UNITED STATES PATENT AND TRADEMARK OFFICE

APPLICATION NO.	FILING DATE	FIRST NAMED INVENTOR	ATTORNEY DOCKET NO.	CONFIRMATION NO.
09/762,713	03/08/2001	Klaus Krinner	F-6818	7592

Office Action Summary

DETAILED ACTION

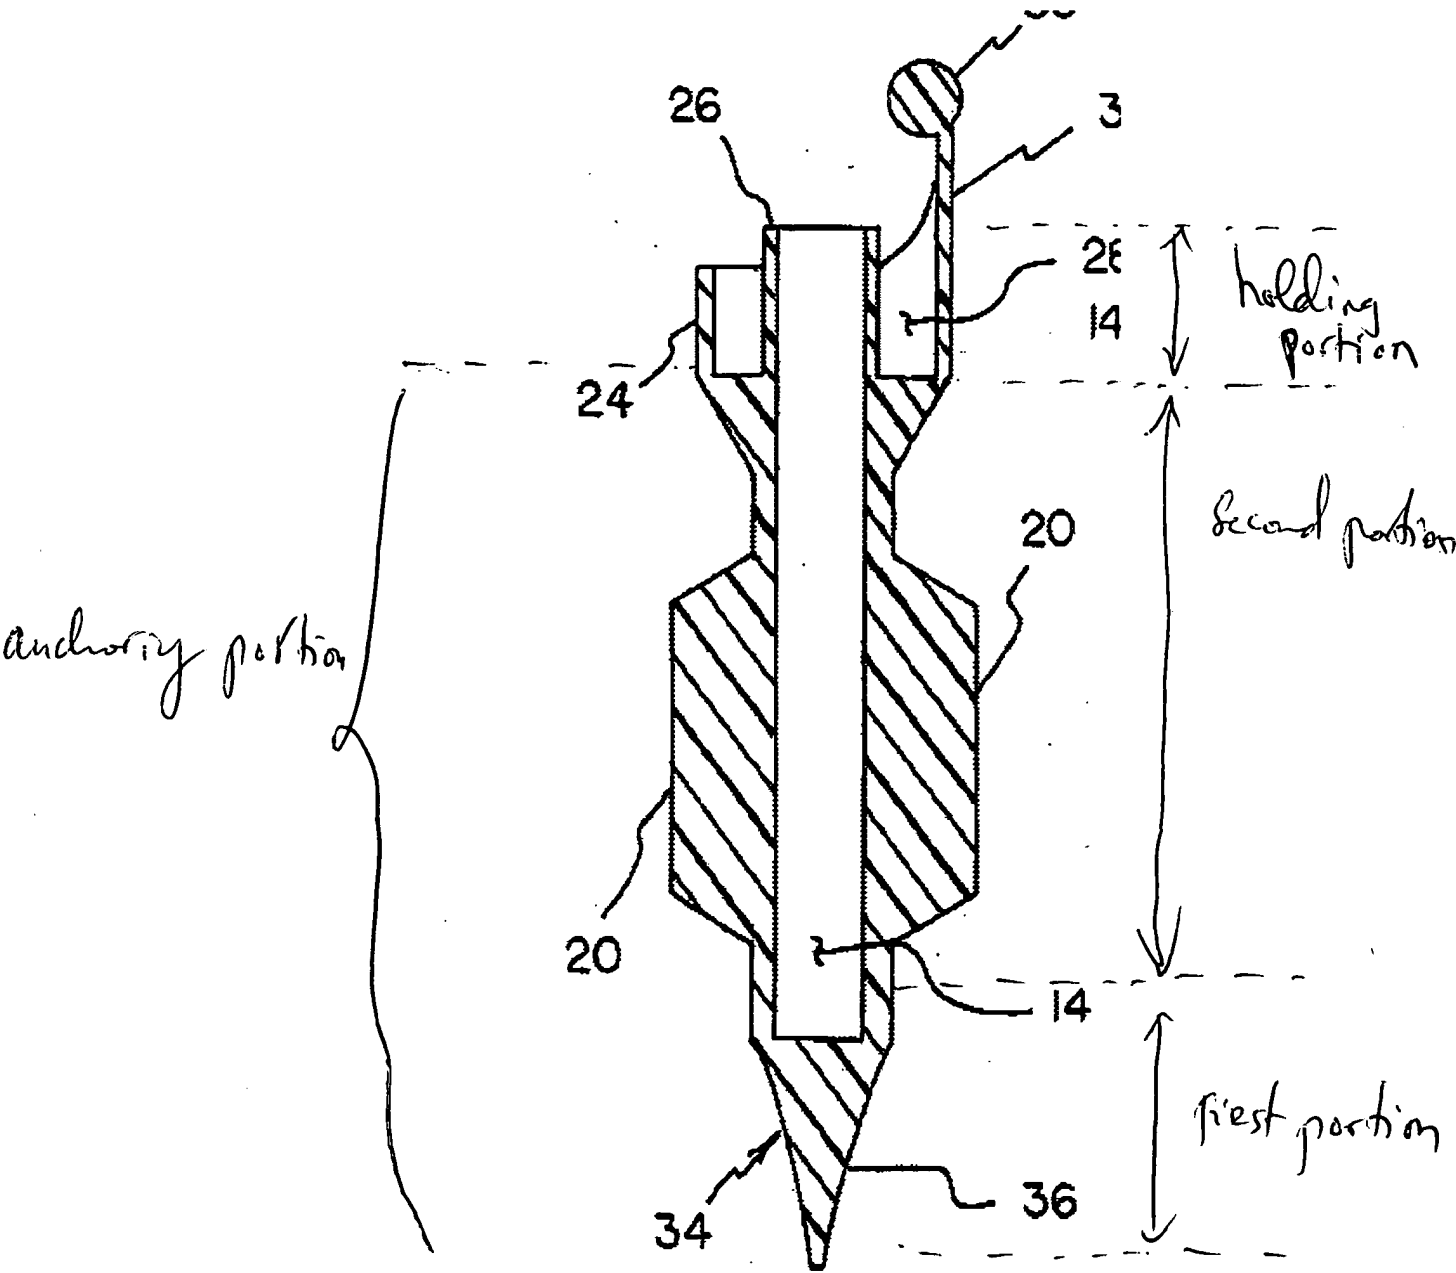
Claims 35-39, 42-45, 47-49 and 52-53 are rejected under 35 U.S.C. 102(b) as being anticipated by US Patent no. 5,524,844 to Lesar.

Regarding claims 35-39, 42-45, 47-49 and 52-53, Lesar discloses substantially all of the limitations of these claims as evidently shown on Fig. 7 for example (See marked-up below).

Regarding claim 40, although Lesar appears to be showing the difference between the first cone angle and the second cone angle between about 1 and 3 degrees. But Lesar does not particularly or expressly disclose as such. Nonetheless, it would have been an obvious matter of the design choice to make the cone angles between 1 and 3 degrees, since such a modification would have involved a mere change in the angle of the component and one skilled in the art could have make a variety of different angles if so desired.

Regarding claim 50, Lesar discloses the tip what appears to be a rectangular in shape, but also does not disclose the tip being a square in shape. It would also have been an obvious matter of the design choice to make the shape of the tip being a square since such a modification would have involved a mere change in the shape and one skilled in the art could have make a variety of different shapes if so desired. . Nevertheless, the particular shape claimed by the Applicant is nothing more than one of numerous shapes that a person having ordinary skill in the art provides for using routine experimentation based on its suitability for the intended use of the invention. See *In Re Daily*, 149 USPQ 47 (CCPA 1976).
